Burlington Planning Commission Special Meeting Wednesday, July 6, 2016, 6:30-9:00 P.M. Contois Auditorium, Burlington City Hall, 149 Church Street

TO: JANE KNODELL, COUNCIL PRESIDENT
BURLINGTON CITY COUNCILORS
FROM: BURLINGTON PLANNING COMMISSION
DATE: JULY 11, 2016
RE: PLANNING COMMISSION TRANSMITTAL OF *ZA-16-14 DOWNTOWN MIXED USE CORE OVERLAY*

As revised by the Planning staff to reflect Planning Commission comments & concerns– July 1, 2016.

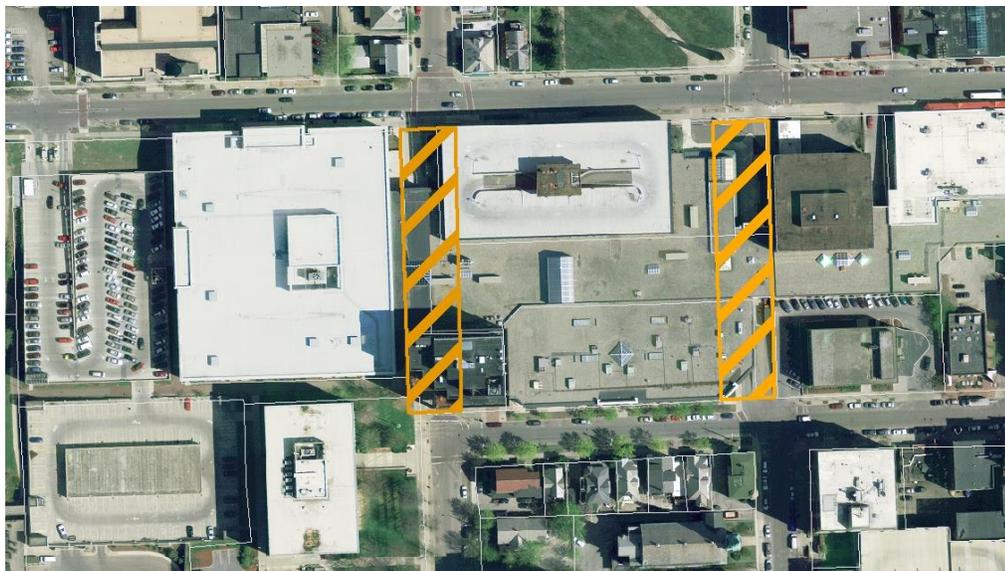
Comment [DEW1]: This will ensure that the proposed north-south connectivity on Pine and St. Paul streets envisioned in planBTV is accomplished. The City will have 120-days to initiate proceedings to acquire any land within this area that may be proposed for new development.

Figure 4.4.1-2 Measuring Height Limits for Church Street Buildings

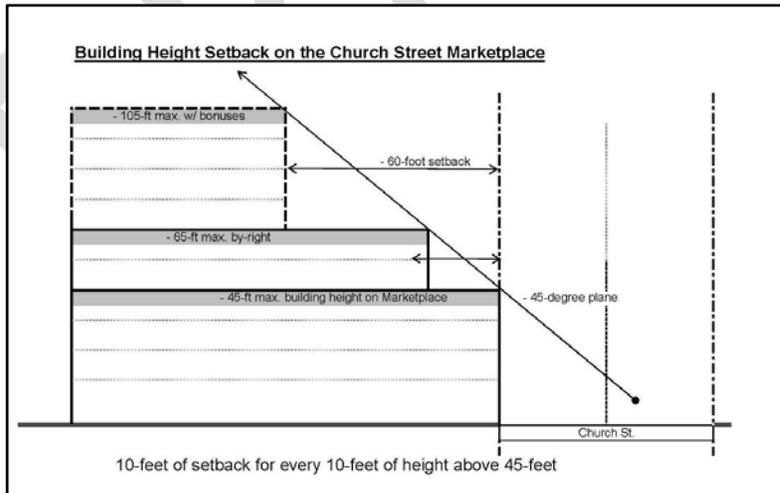
For the purposes protecting the historic character and scale of buildings along the Church Street Marketplace, the maximum height of any building fronting on Church Street shall be limited to ~~38 feet~~ 4-stories not to exceed 45-feet. Any portion of a building within 100 feet from the centerline of Church Street exceeding 45-feet shall be set-back a minimum of ~~16~~ 10-feet for every 10-feet of additional building height above ~~38~~ 45-feet.

Comment [DEW3]: While outside of the proposed new overlay, this change is already envisioned as part of the currently proposed form-based code to provide better compatibility of building heights on Church Street.

Figure 4.4.1-2 Measuring Height Limits for Church Street Buildings

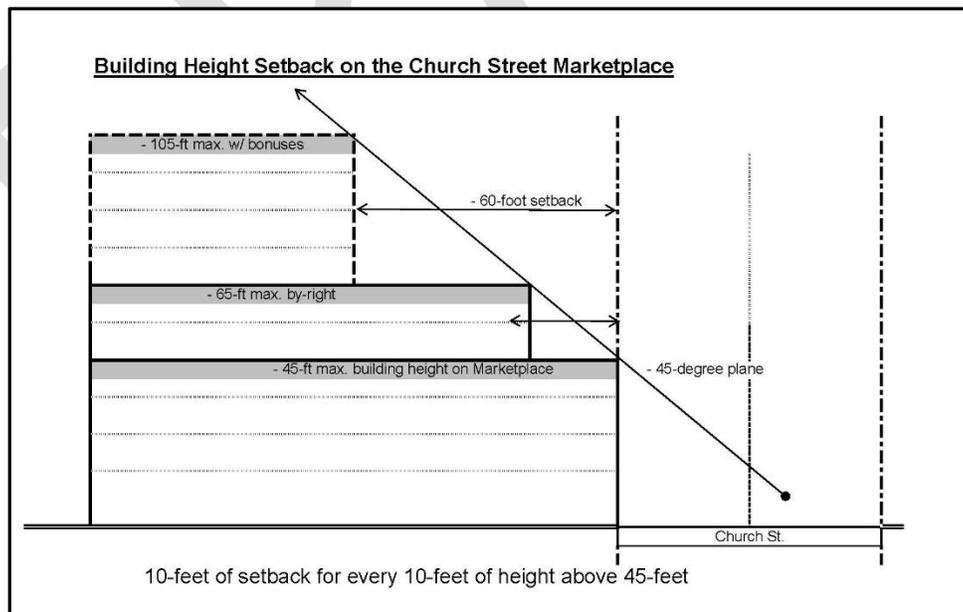
For the purposes protecting the historic character and scale of buildings along the Church Street Marketplace, the maximum height of any building fronting on Church Street shall be limited to ~~38-feet~~ 4-stories not to exceed 45-feet. Any portion of a building ~~within 100-feet from the centerline of Church Street exceeding 45-feet~~ shall be set-back a minimum of ~~16~~ 10-feet for every 10-feet of additional building height above ~~38~~ 45-feet.
